Drawing title
CEILING FINISHES
RCP
LEVEL 09

Project stage
CONSTRUCTION

Drawing number
SLH-ANO-P0-09-DR-A-38209

01 CEILING FINISHES
LEVEL 09 1:100

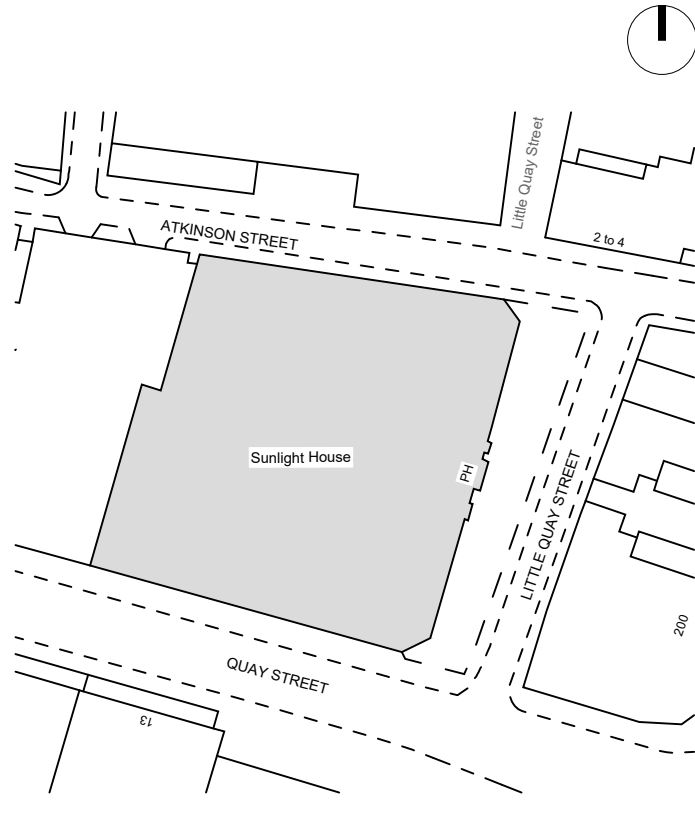
PROPOSED EXTENSION OF THE BULKHEAD.
TO EXTEND THE FULL LENGTH OF THE COFFER AND STOP AROUND 300MM IN FRONT OF THE WINDOW, AND WILL FORM A SIMILAR DETAIL TO THE WINDOW DETAIL WITHIN THE WC.
ADD ANOTHER SPOTLIGHT TO THE BULKHEAD AND OMIT ONE LINEAR LIGHT

C02- BULKHEAD REVERTED BACK TO THE ORIGINAL DESIGN FROM TENDER

LOCAL EXTENSION OF THE BULKHEAD TO ALLOW TO CONCEAL THE SERVICES ROUTED TO THE PLANTROOM.

C02- DRAWING UPDATED TO REFLECT SETTING BACK OF BULKHEAD AND LOUVER LAYOUT.

REDUCE THE BULKHEAD IN THIS AREA

PROPOSED EXTENSION OF THE BULKHEAD.
TO EXTEND TO THE MIDDLE OF THE COFFER.
ADD ANOTHER SPOTLIGHT TO THE BULKHEAD AND OMIT ONE LINEAR LIGHT
